ADDENDUM NO. 5

**CONTRACT RFB-RC-SWR-CIP 2020-02
MAIN PUMP STATION UPGRADE PROJECT**

**ROCKLAND COUNTY SEWER DISTRICT NO. 1
ROCKLAND COUNTY, NEW YORK**

September 8, 2021

SECTION B-B (202, 203)

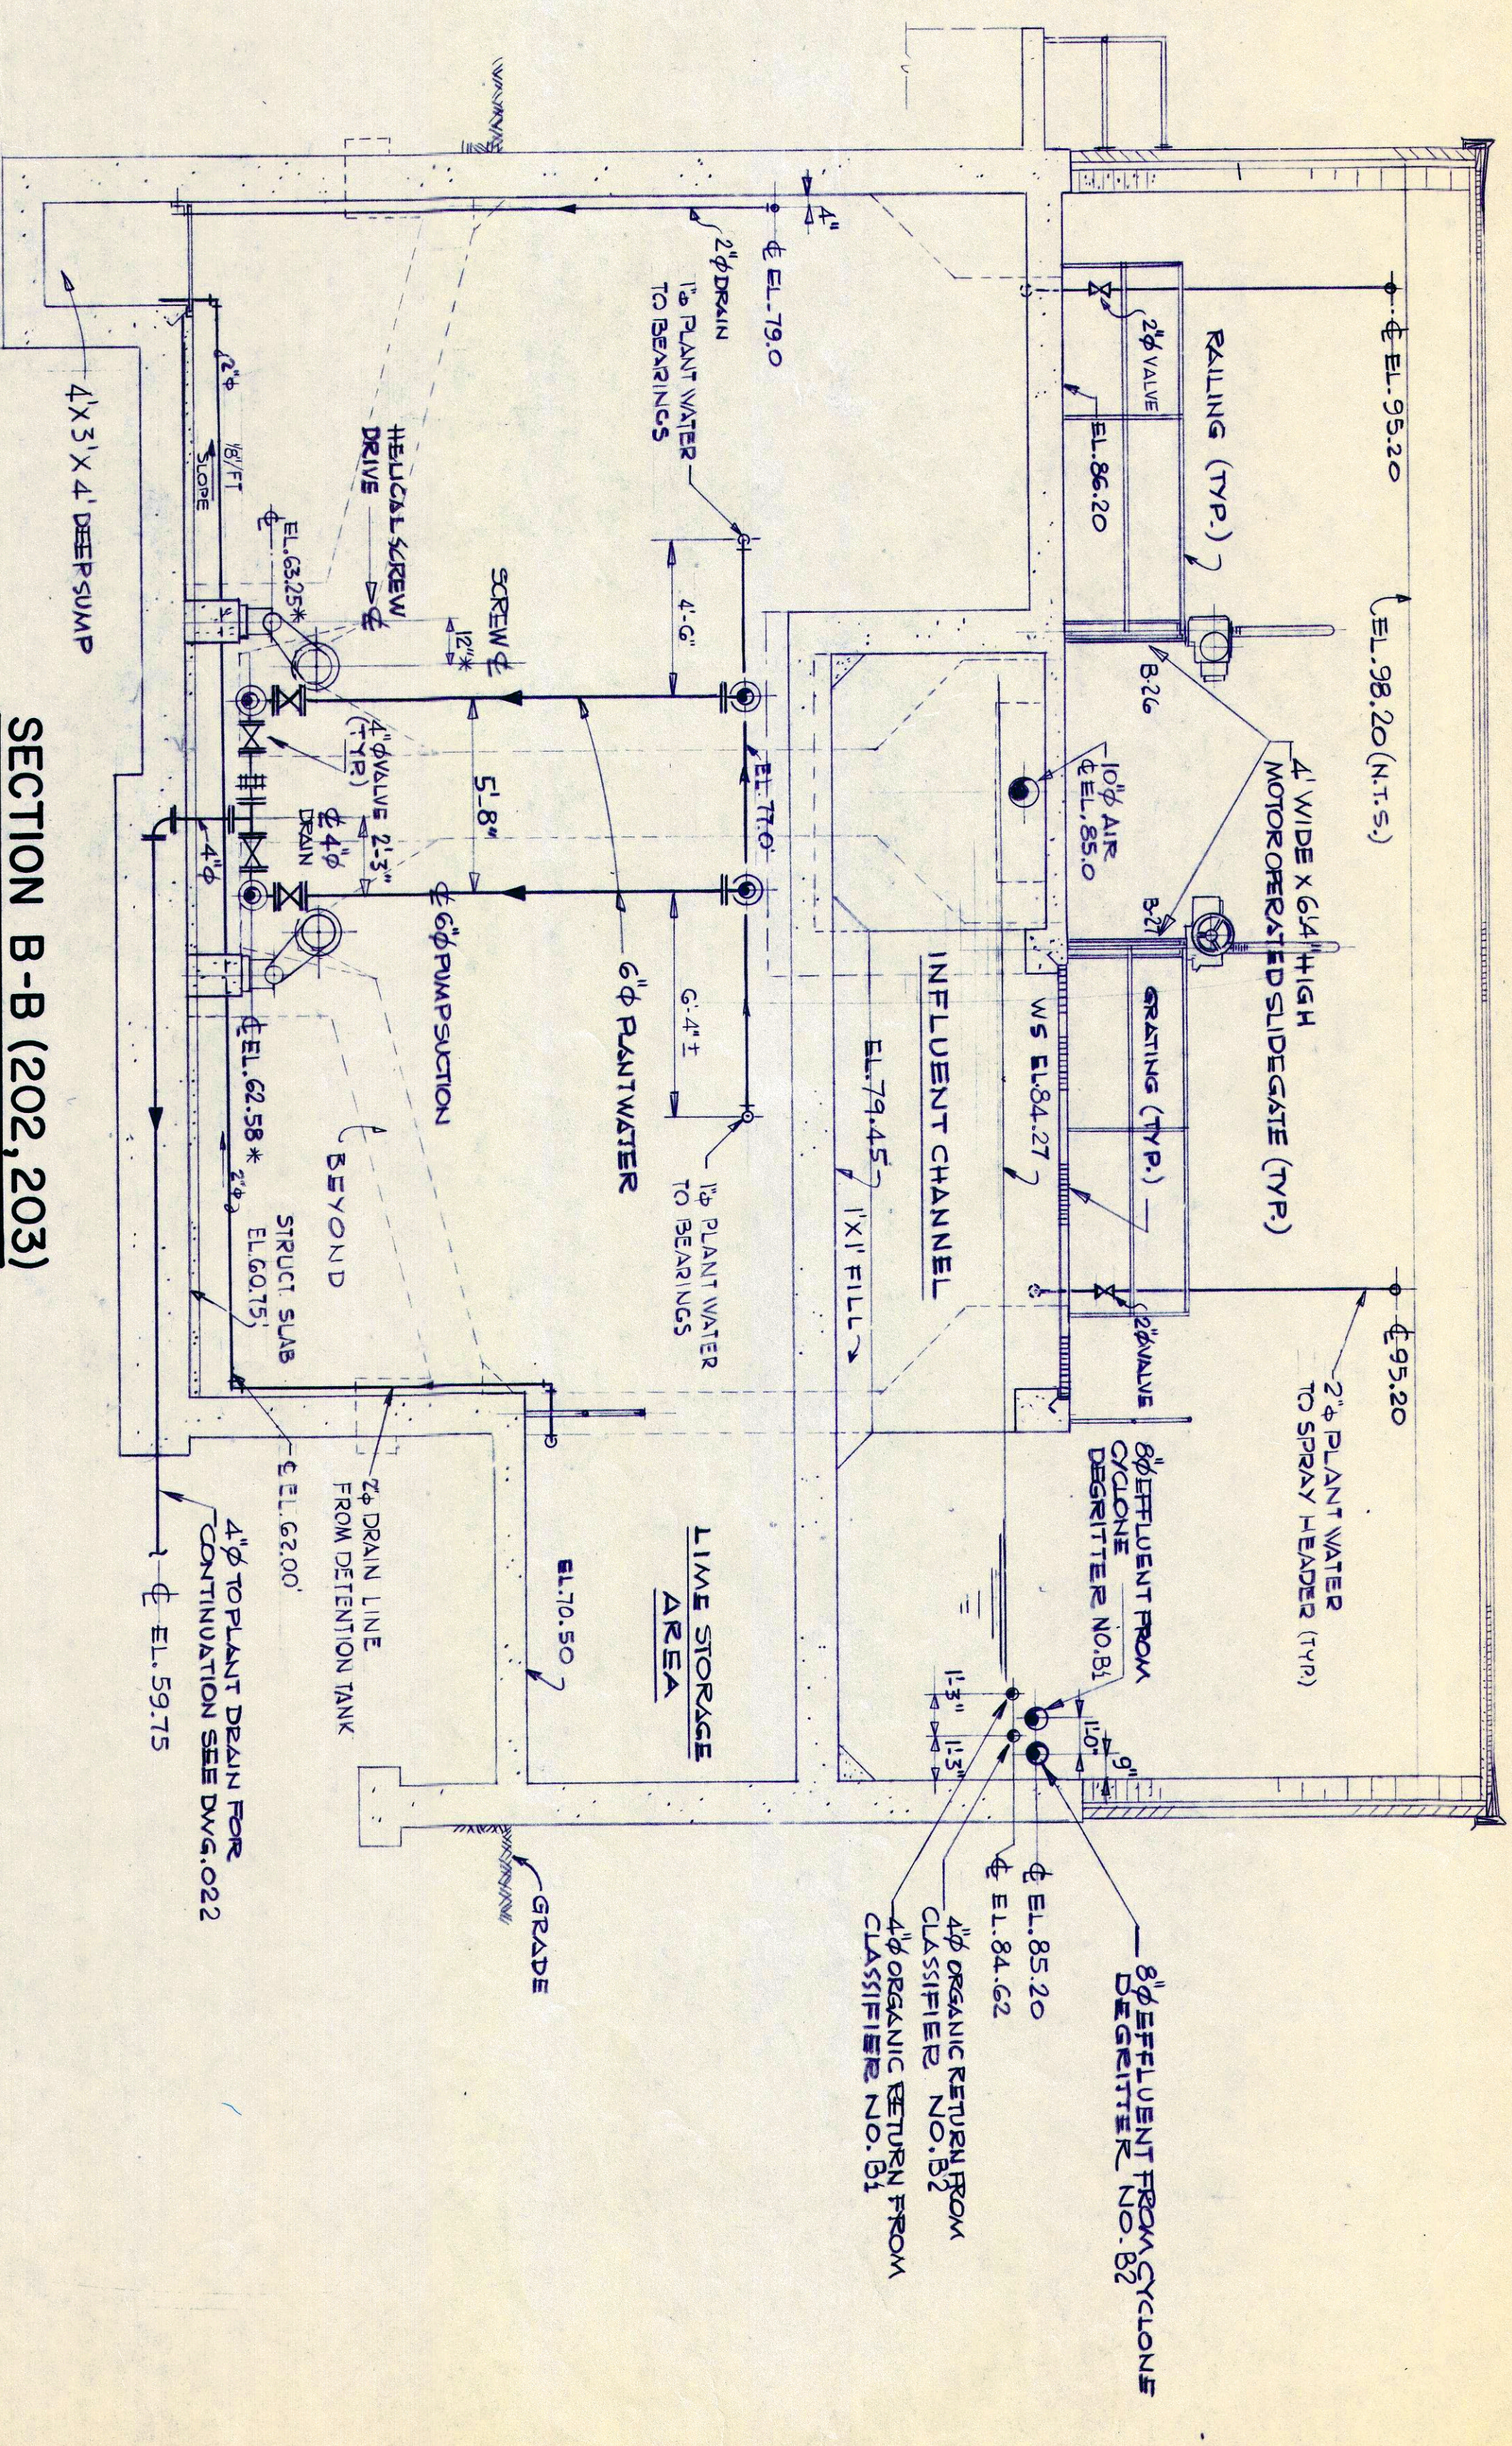
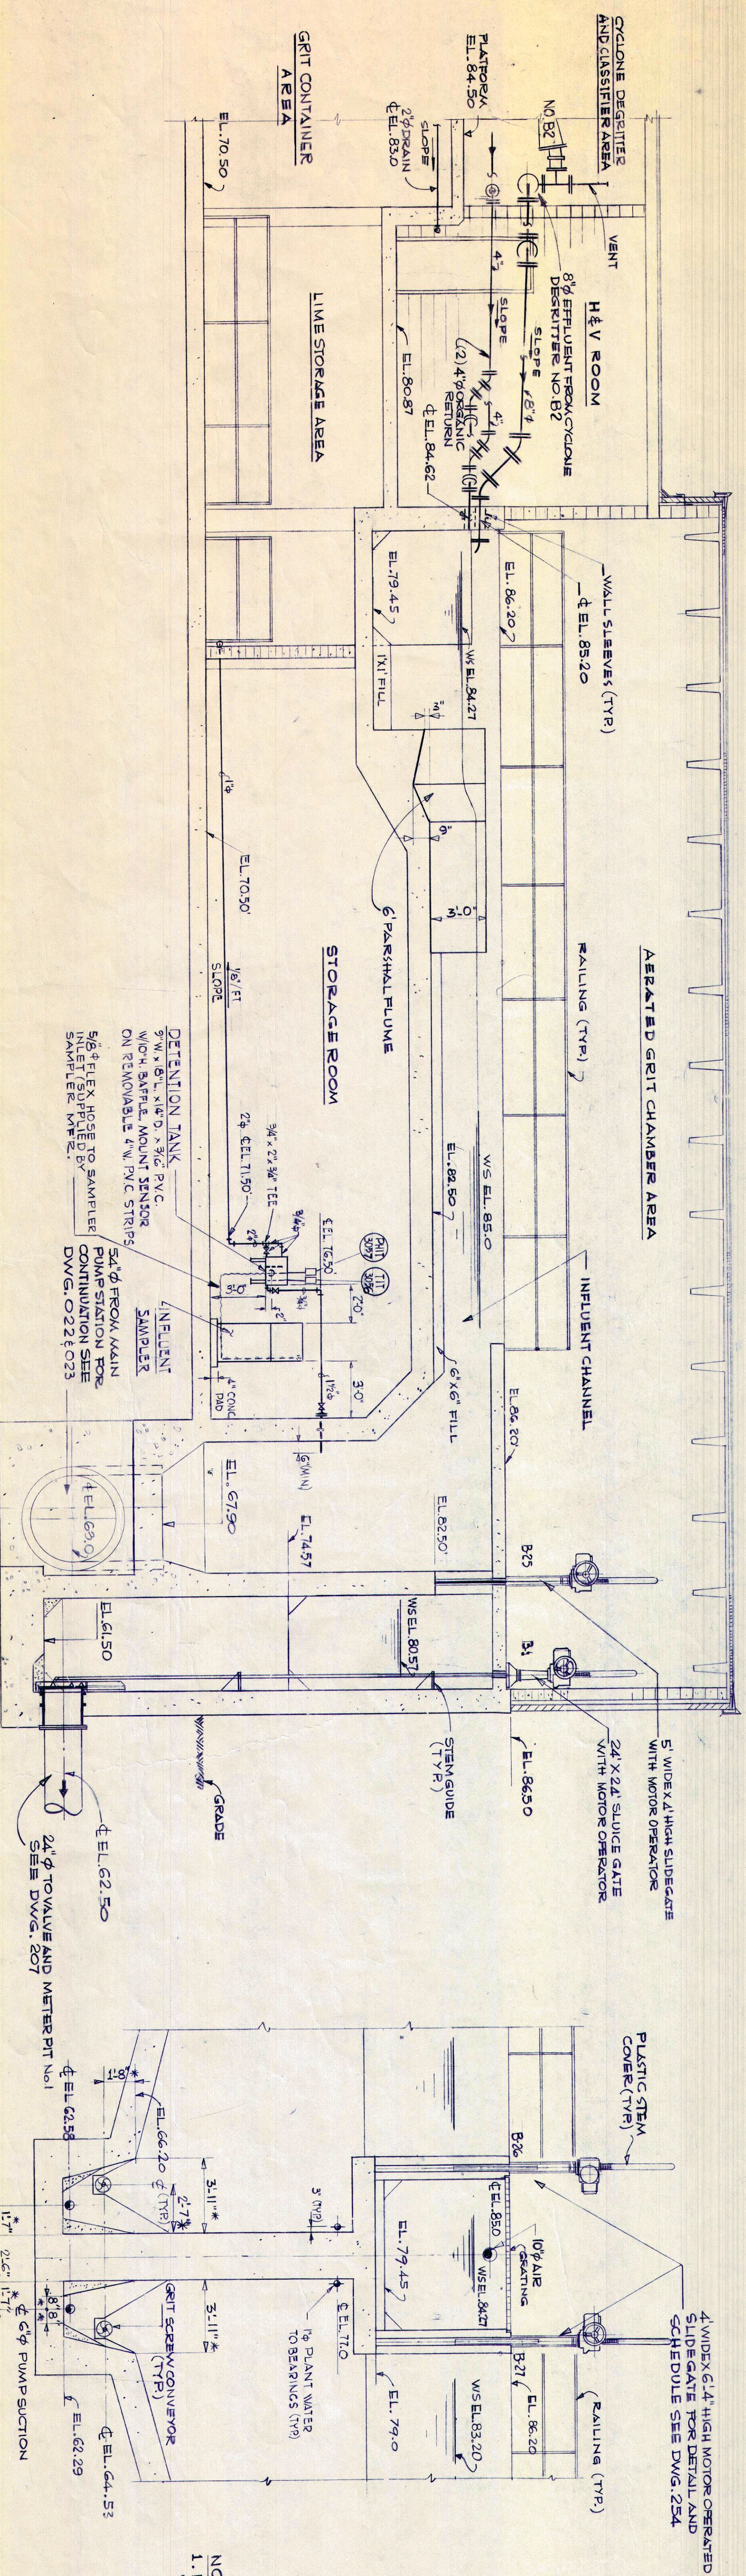
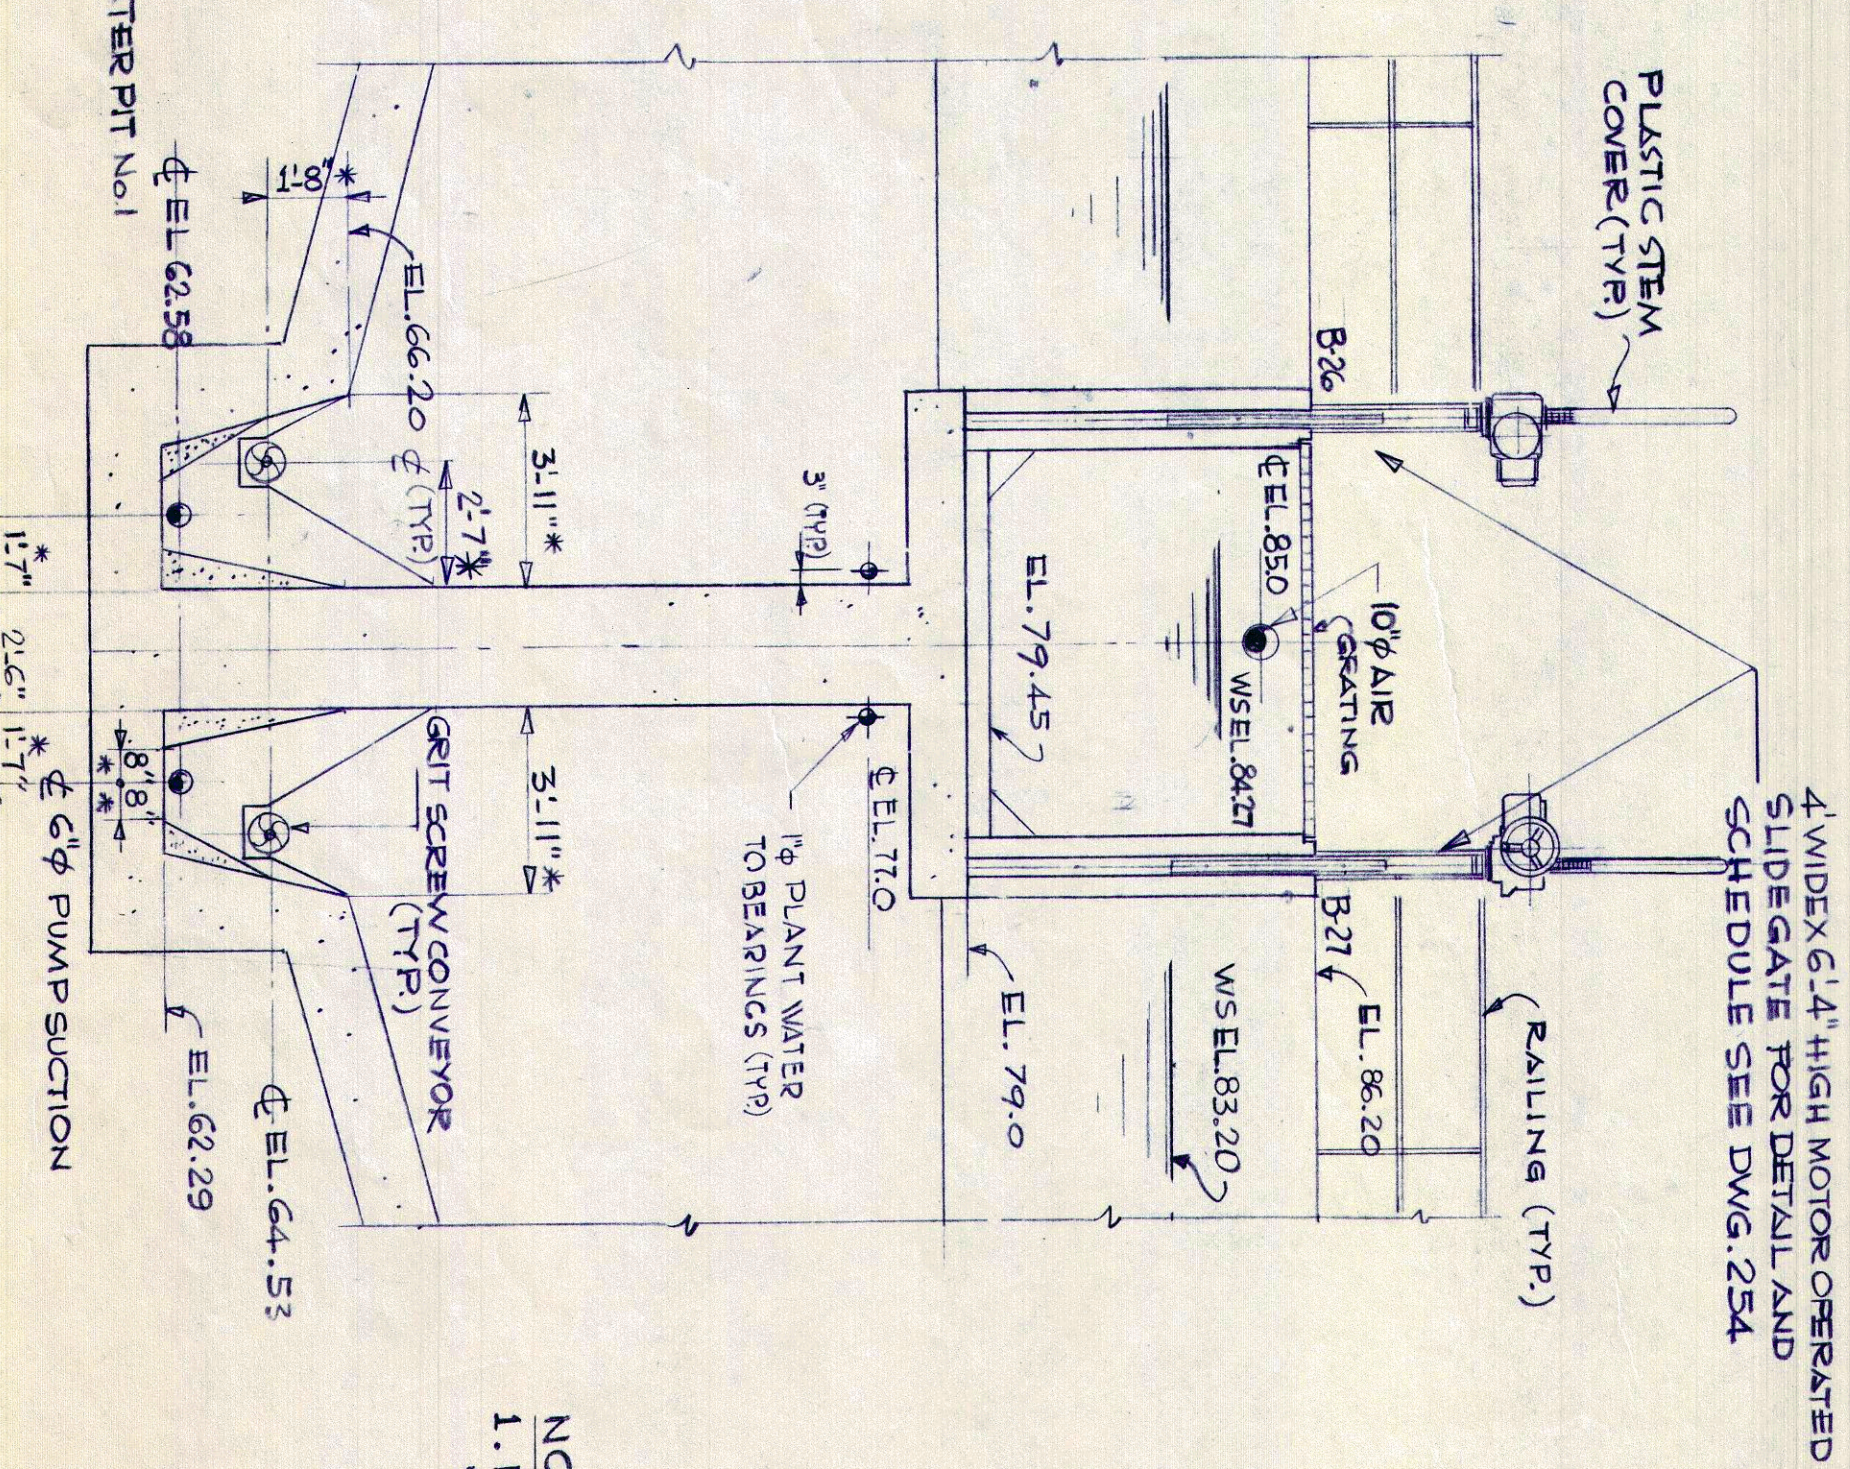
From the additional drawings provided in Addendum #2, we are unable to determine the following information related to the Grit Tanks Influent Channel upstream of the Parshall Flume in the Grit Building:

- a. Channel width
- b. Channel depth
- c. Normal water depth

Please provide this information as it is necessary in order to determine the bulkhead required during bypass operations.

See Attachment 2 - Contract 82 Vol II Drawings. Water depth is dependent of flow from the main pump station.
